EMERGENCY AIRWORTHINESS DIRECTIVE

AD 2007-18-51; Docket No. FAA-2007-29089; Directorate Identifier 2007-NM-214-AD

Emergency airworthiness directive (AD) 2007-18-51 is sent to all owners and operators of Boeing Model 737-600, -700, -700C, -800, -900, and -900ER series airplanes.

Figure 1

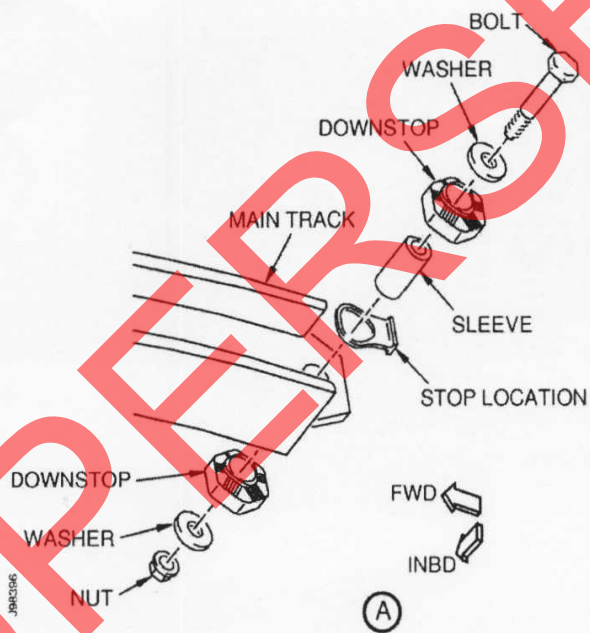
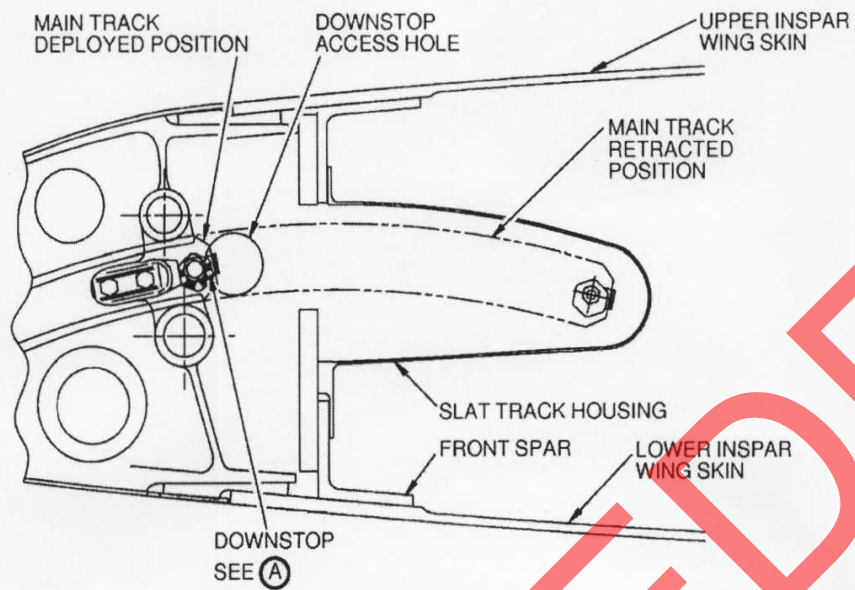
(1) Do a detailed inspection of each main slat track downstop assembly to verify proper installation of the slat track hardware (the bolt, washers, downstops, sleeve, stop location, and nut shown in Figure 1 of Boeing Service Letter 737-SL-57-084-B, dated July 10, 2007, and in this AD). If any part is missing or is installed improperly, before further flight, install a new or serviceable part using a method approved in accordance with the procedures specified in paragraph (g) of this AD; and do a detailed inspection of the inside of the slat can for foreign object debris (FOD) and damage. Before further flight, remove any FOD found and repair any damage found using a method approved in accordance with the procedures specified in paragraph (g) of this AD. Using Boeing Correspondence (Multi-Operator Message) Service Request ID 1-523812011, issued August 25, 2007, is one approved method for verifying proper installation; installing a new or serviceable part; and inspecting for damage and FOD, and removing FOD and repairing damage. Repeat the actions required by paragraph (f)(1) of this AD thereafter at intervals not to exceed 3,000 flight cycles:

(2) Apply a torque between 50 to 80 inch-pounds to the nut. The bolt head must be held with the torque applied to the nut.
